**Town of Kittery
 Planning Board Meeting
 February 23, 2023**

ITEM 1 – 22 Shapleigh Road– Site Plan - Preliminary Plan Review

**RE: Town of Kittery, Planning Board Services
Fair Tide, Inc. Development
Tax Map 15, Lot 64
CMA #591.152**

D1

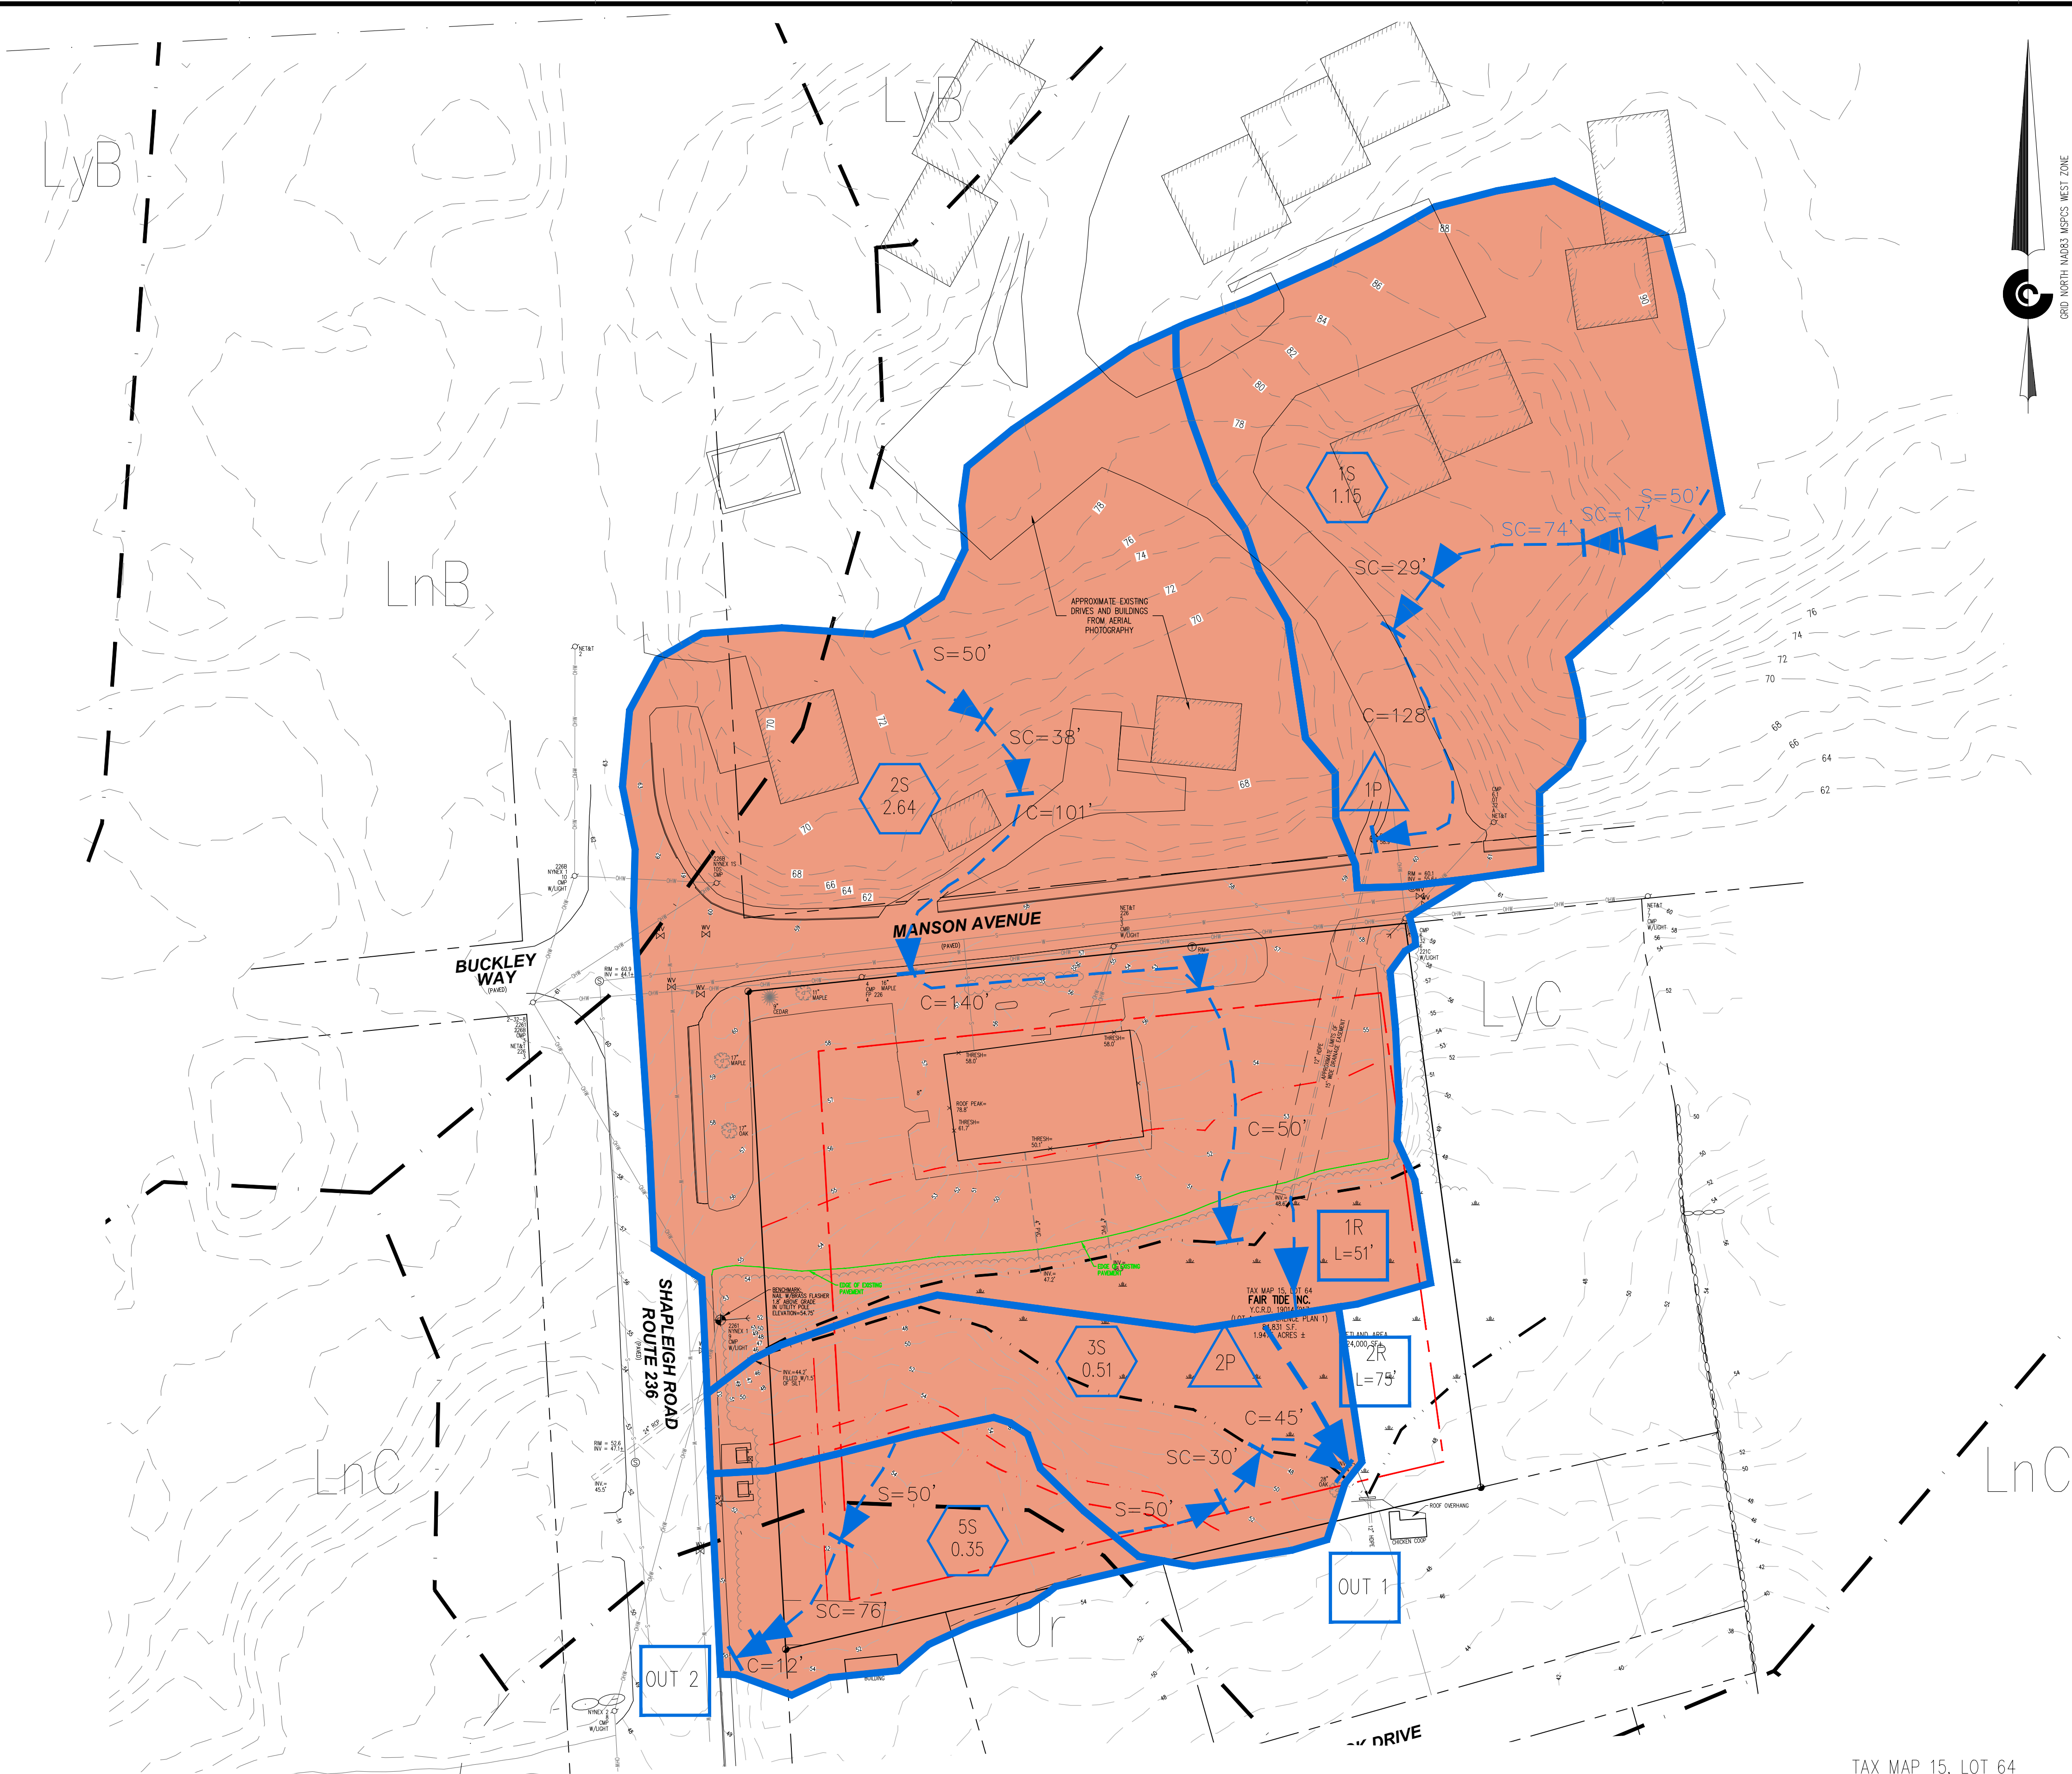
Sheet D1:

1. Is the entire drainage area (including property north of Manson Avenue) soil type D? If so, remove the other soil types from the soils legend.
2. Remove the Tc Flow Path & Direction Post-Development linetype from the legend.
3. It isn't clear how stormwater from subcatchment 2S gets out of the depressed area north of the building to cross the parking lot.

SHEET: 2 OF 2

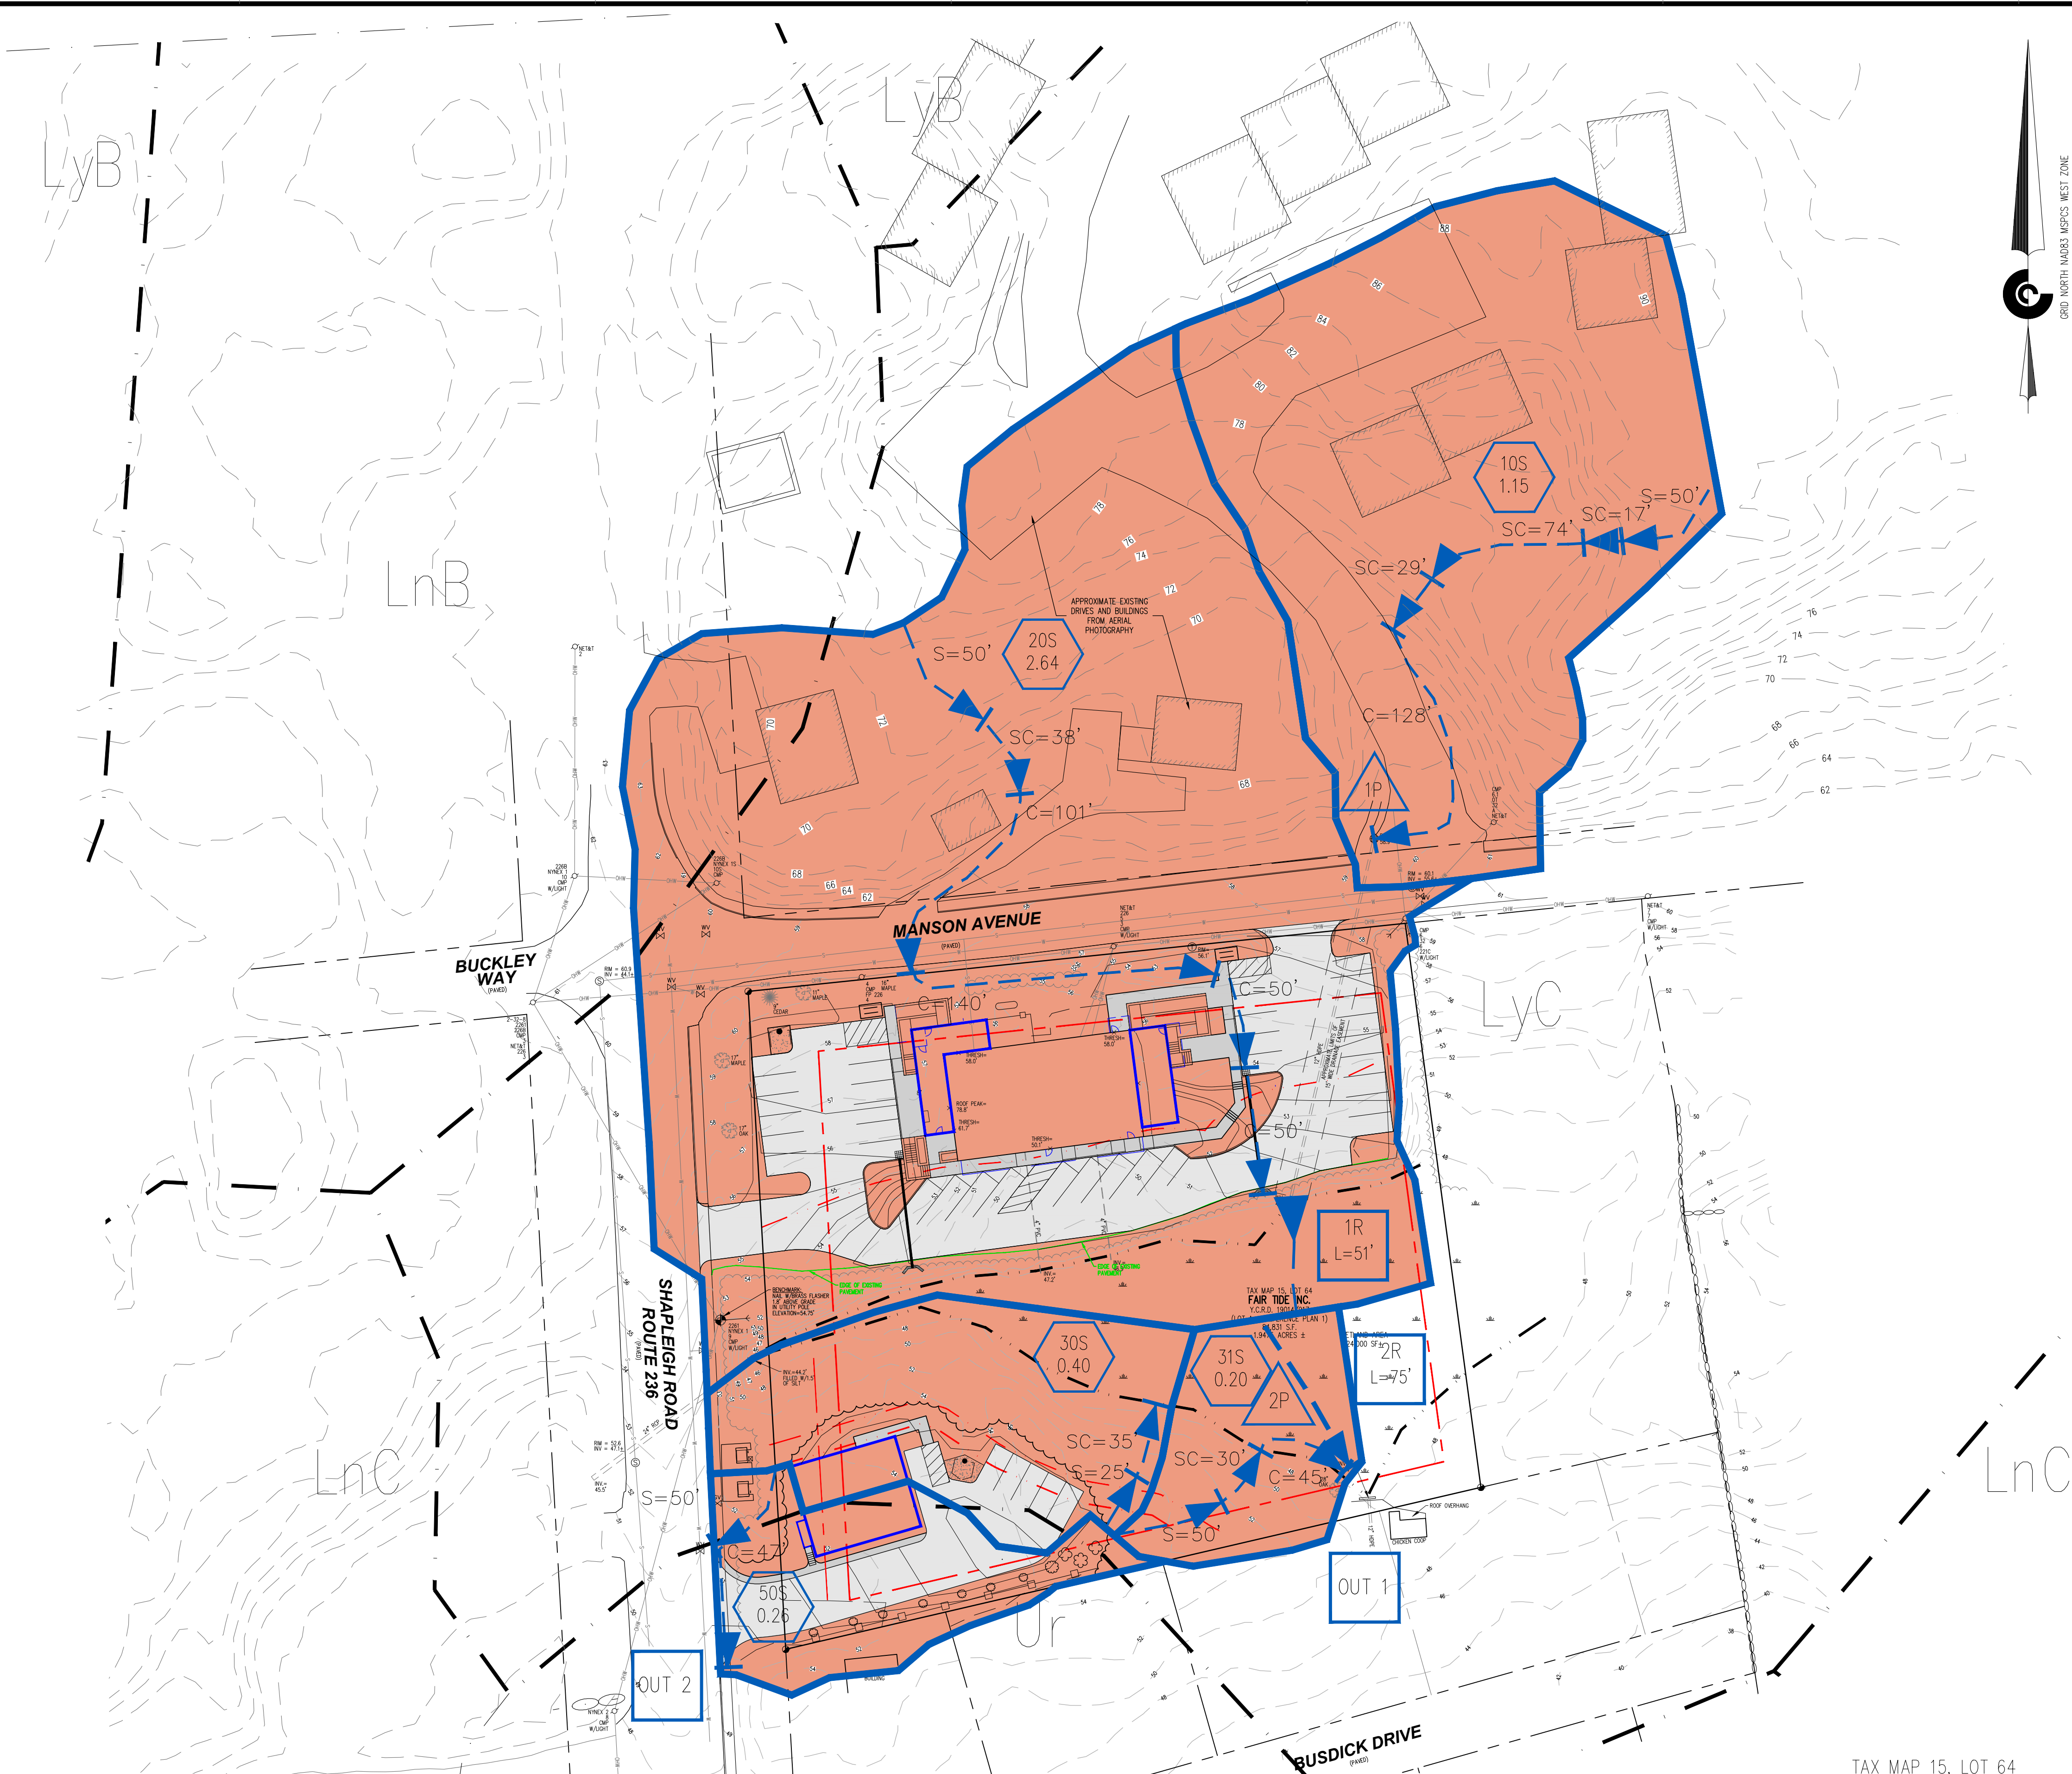
Sheet D2:

1. Is the entire drainage area (including property north of Manson Avenue) soil type D? If so, remove the other soil types from the soils legend.
2. The proposed parking areas should be shaded for their respective soil type.
3. Remove the Tc Flow Path & Direction Pre-Development linetype from the legend.
4. Remove the edge of existing pavement line.
5. What is the significance of the red lines? Please define these in the legend or remove them or make them black or gray.
6. Without showing the final grading of the “area to be filled” to the north of the building, the stormwater flow path for subcatchment 2S does not appear to be correct.
